## NIAGARA MOHAWK POWER CORPORATION

Re: Nine Mile Point Unit 1  
Docket No. 50-220

Pursuant to Section 50.59 of the Commission's Regulations, Niagara Mohawk plans to make a change in its facility under Provisional Operating License No. DPR-17. Briefly, this change consists of installation of plugs in the upper end of the non-instrumented incore housings.

940-2-E  
Rev A  
2-1-74  
IN-CORE HSS Plug  
Layout

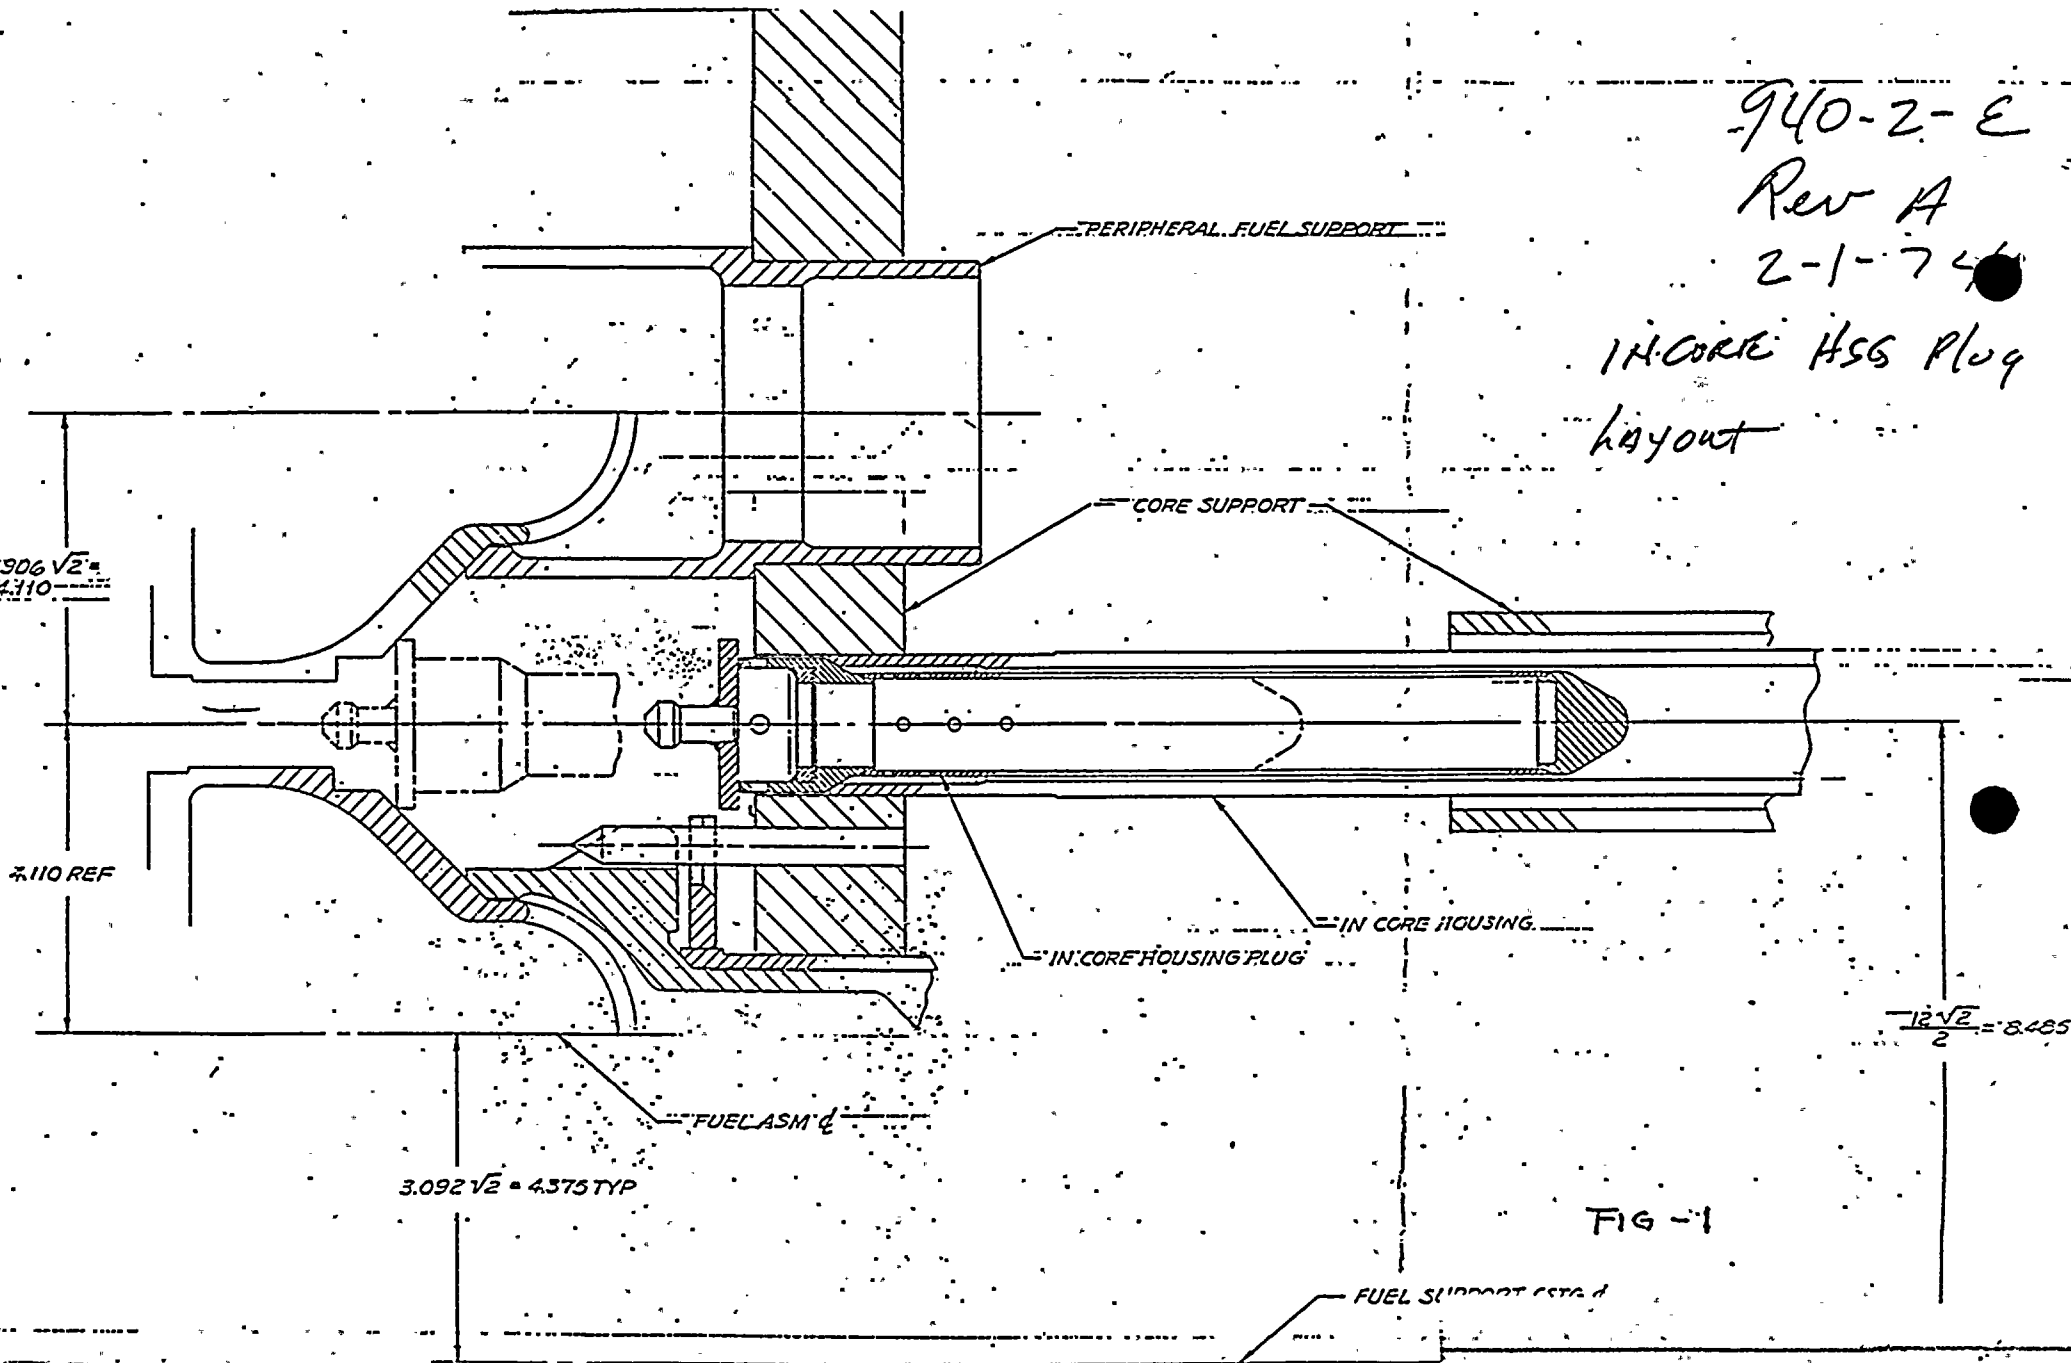
The modification is designed to prevent the accumulation of radioactive scale in the non-instrumented incore housing flanges under the reactor vessel. The scale accumulation in these housings produces high radiation levels under the vessel and interferes with control rod drive maintenance operations.

The proposed facility modification provides for installation of plugs in the upper end of the non-instrumented incore housing as shown in Figure 1 attached. This will prevent the accumulation of radioactive scale in these incore housings. The four fuel assemblies surrounding the incore housing would be removed and the plug inserted. As can be noted from the attached figure, a fluid path is provided through a screen into the core housing from the area between the upper and lower core support plates. This will prevent any pressurization force buildup within the incore housing by providing equalized pressures in and out of the tube. The plug assembly cannot be forced completely out of the incore housing due to the normal positioning of the fuel assemblies and the length of the plug assemblies. The twenty-two spare incore housing locations are shown on Figure 2.
